RE: Public Comments on the Amendment to Application for Revision 20-1 and Proposed Cost Estimate, Closure/Closeout Plan Update, Cunningham Hill Mine, Permit No. SF002RE

Re: **Comments on Revised October 2021 CCP update for MMD Permit No. SF002RE,
LAC Minerals (USA) LLC Cunningham Hill Mine**

Figures 1 and 2. Graphs of POINT PRECIPITATION FREQUENCY ESTIMATES, NOAA Atlas 14, Volume 1, Version 5 GOLDEN Station ID: 29-3592 Location name: Sandia Park, New Mexico, USA*

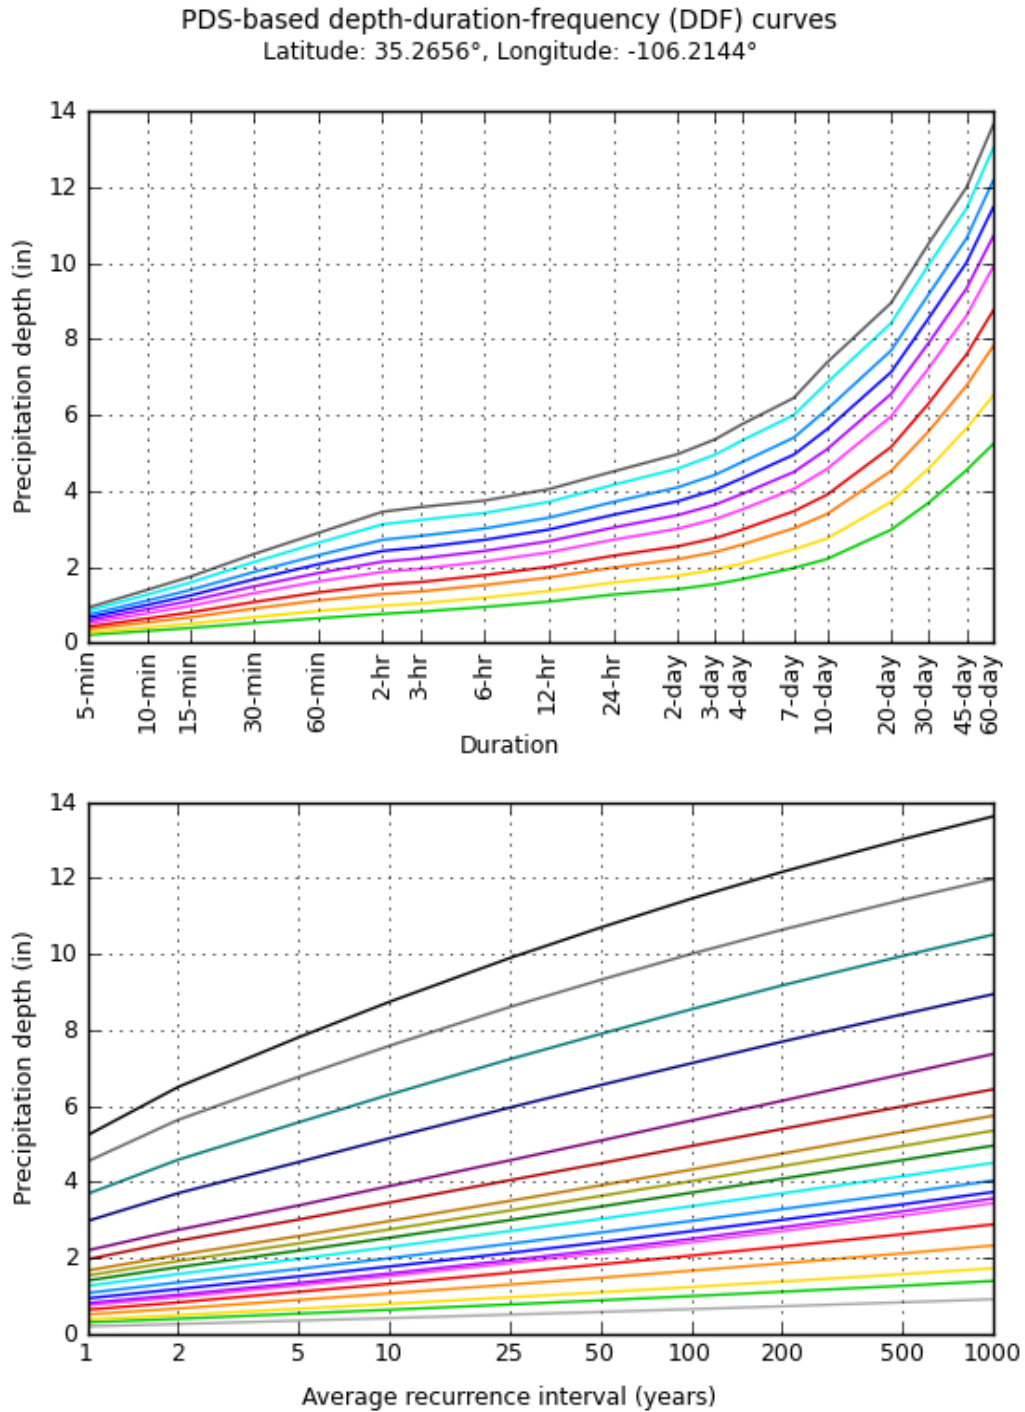
The National Weather Service provides information for specific weather stations including the Golden station referenced in the CHM CCP.⁵ As shown in Table 1 and Figures 1 and 2, the expected precipitation from a 1 in 100 year 24-hr storm event is estimated at 3.37 inches whereas a 1 in 1,000 year 24-hr event is estimated at 4.51 inches. Precipitation from a 1 in 100-year wet period of 30-days is estimated at 8.55 inches whereas a 1 in 1,000 year 30-day event is estimated at 10.5 inches. As has been experienced over the past decade⁶, 1 in 100 year 24-hr storm events are without question becoming more frequent, and 1 in 1,000-year events have occurred in the recent past and are equally if not more likely to occur in the future. This past 2022 Monsoon's precipitation amount was the second wettest in the 25-year period of record kept by Santa Fe County as shown in Figure 3.

Recommendations: The CHM CHP should be revised to recognize and address how climate is expected to be affected by climate change. The agencies should take into consideration the potential for more frequent intense storm events and wet years in their consideration as to the design, construction, maintenance and replacement of engineered covers and stormwater controls features as discussed later in these comments. Additionally, any models or other information that has been produced on behalf of LAC should be based on actual daily data and not average data which significantly compromises such efforts.

Table 4.

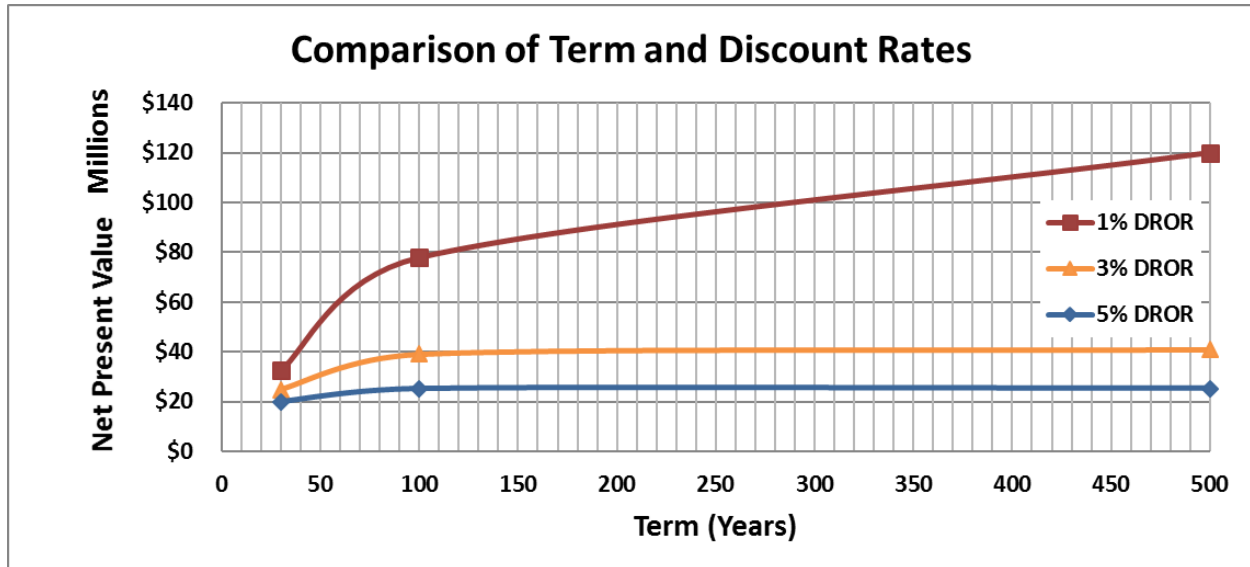
In particular the requirement from NMED to consider long-term costs for activities for 100 years is significant in that the use of that time period is intended to address long-term costs that could actually occur over hundreds, thousands and even tens of thousands of years into the future if present circumstances were to be applied. The recognition that the CHM is not a walk-away proposition is important in that it signifies that in order to ensure that the liability for conducting the necessary future monitoring, maintenance and water treatment tasks does not ultimately become a public/taxpayer liability, a cash or equivalent trust fund based on conservative fiscal assumptions relative to financial assurance must be established. This means that in addition to ensuring the cost estimate is accurate, the estimate should also be performed assuming a longer time period such as 500-years, and a using a conservative assumption as to future inflation and interest, and assume a low net discount rate, such as 1%. How this approach affects the amount of financial assurance is shown in Table 4.

Depending on the Discounted Rate of Return (DROR), which is the rate of interest received on funds invested minus the inflation rate, the impact on the amount of funds estimated is significant. For a 100-year period, using this example, a 5% DROR would result in a Net Present Value (NPV) being calculated of approximately \$25M, whereas using a 3% DROR would result in a NPV of approximately \$38M, and a 1% DROR would result in a NPV of approximately \$75M. It should be noted that currently, with inflation exceeding the interest rate obtainable on typical investment funds appropriate for financial assurance, the DROR would be negative resulting in an even larger amount of financial assurance being necessary than that calculated for the 1% case.

The impact of using a 500-year period is also demonstrated in Table 4. If a 5% DROR is used the result would be to add less than a percent to the NPV. If 3% is used the result would be to increase the amount from approximately \$38M to \$41M. However, if a conservative rate of 1% is used the NPV increases from approximately \$75M if 100 years is used to approximately \$120M if 500 years is used.

Figure 5. Montana Tunnels Open Pit Highwall Failure Along Clancy Creek. (Photo by Christopher Boyer)

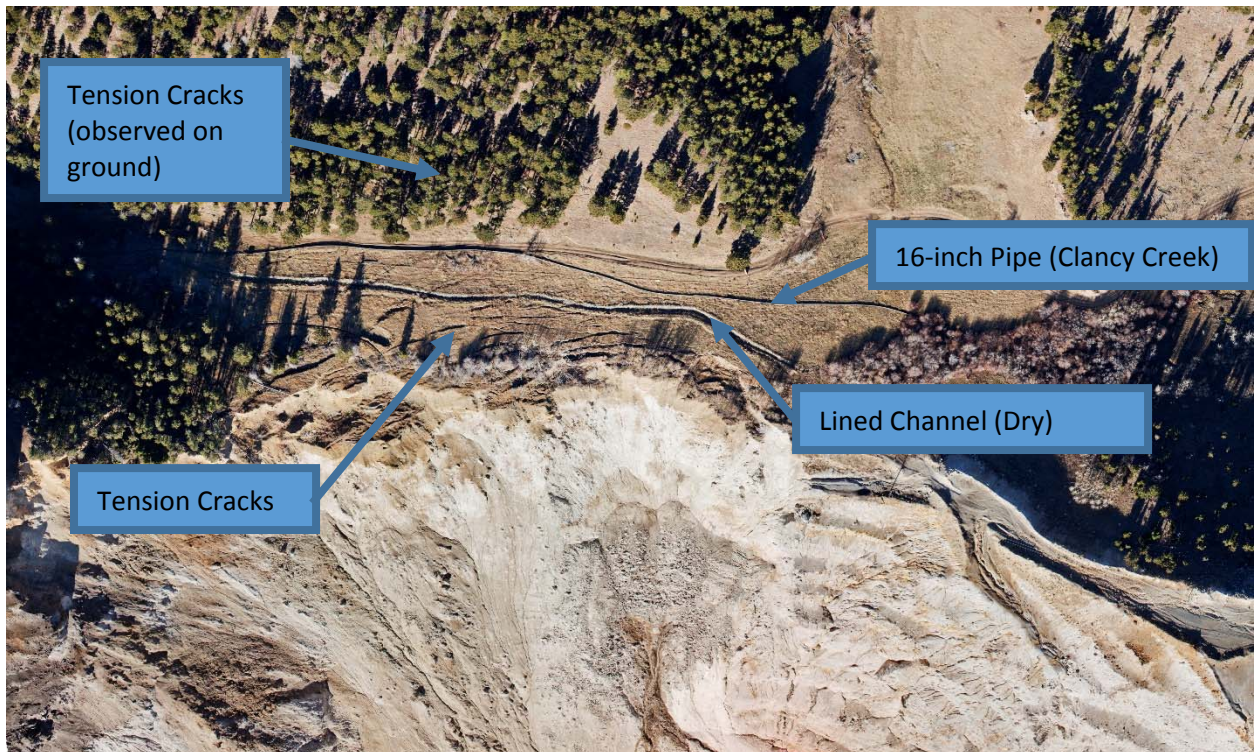
Clancy Creek, instead of being unimpacted as predicted in the original 1998 and subsequent 2008 FEISs, was significantly impacted and has been moved into a 16-inch pipe around the mine pit highwall, as shown in Figure 5. It is evident that pit highwall degradation that has occurred since 2009 has resulted in the need to reroute Clancy Creek sooner rather than centuries into the future as predicted. Additionally, the contingency of constructing another channel is no longer viable, and it is clear that the highwall instabilities are extensive as evidenced by tension cracks extending well beyond the pit perimeter, and it is likely that Clancy Creek will be problematic to restore to an alternative channel, and maintaining the existing flow in a pipe may prove to be problematic as well if the highwall sloughs further or a mass instability occurs.
